Access Compliance Report

Public Rights-of-Way

(Curb Ramps)

Intersection ID: 43350	Main Street: FORESTRIDGE COMMONS DR	Cross Street: PROSPERITY COMMONS DR	Location: W
ADA ID: C5DEFF69E5AA	Ramp Type: PerpDiag	Initial Pass/Fail: Fail	Overall Compliance: No
Severity Score: 22.5			
Codes/Mitigation Info/Possible Solution		Field Measurements/Component Compliance

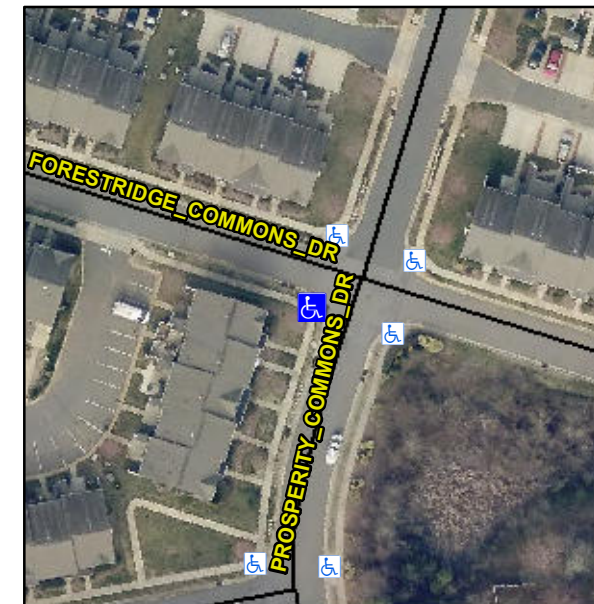
R304.5.1, R304.2.2, R304.5.3

Compliance	Description	Data	Compliance	Description	Data
N/A	Ramp Length (in)	46.0	No	Ramp Slope (%)	11.7
No	Ramp Width (in)	39.0	No	Ramp XSlope (%)	2.2
N/A	Flare Type LT	N/A	N/A	Flare Type RT	N/A
N/A	Flare Slope LT (%)	N/A	N/A	Flare Slope RT (%)	N/A
N/A	Flare Traversable LT?	N/A	N/A	Flare Traversable RT?	N/A
N/A	Landing Length (in)	N/A	N/A	DWS Provided?	N/A
N/A	Landing Width (in)	N/A	N/A	DWS Contrast?	N/A
N/A	Landing Slope (%)	N/A	N/A	DWS Length (in)	N/A
N/A	Landing X Slope (%)	N/A	N/A	DWS Full Width?	N/A
N/A	Landing Curb? (Y/N)	N/A	N/A	DWS Offset (in)	N/A
N/A	Shared Landing?	N/A			
N/A	Gutter Ponding?	N/A	N/A	Gutter Slope (%)	N/A
N/A	Gutter Lip Ht (in)	N/A	N/A	Gutter X Slope (%)	N/A
N/A	Painted X Walk1?	No	N/A	Painted X Walk2?	No
	X Walk 1 Direction	To SE		X Walk 2 Direction	To NE
N/A	X Walk 1 Width (in)	N/A	N/A	X Walk 2 Width (in)	N/A
	X Walk 1 Slope (%)	3.2		X Walk 2 Slope (%)	2.1
	X Walk 1 X Slope (%)	0.4		X Walk 2 X Slope (%)	1.7

Remove & Replace Curb Ramp With Two New Directional Ramps or Equivalent.
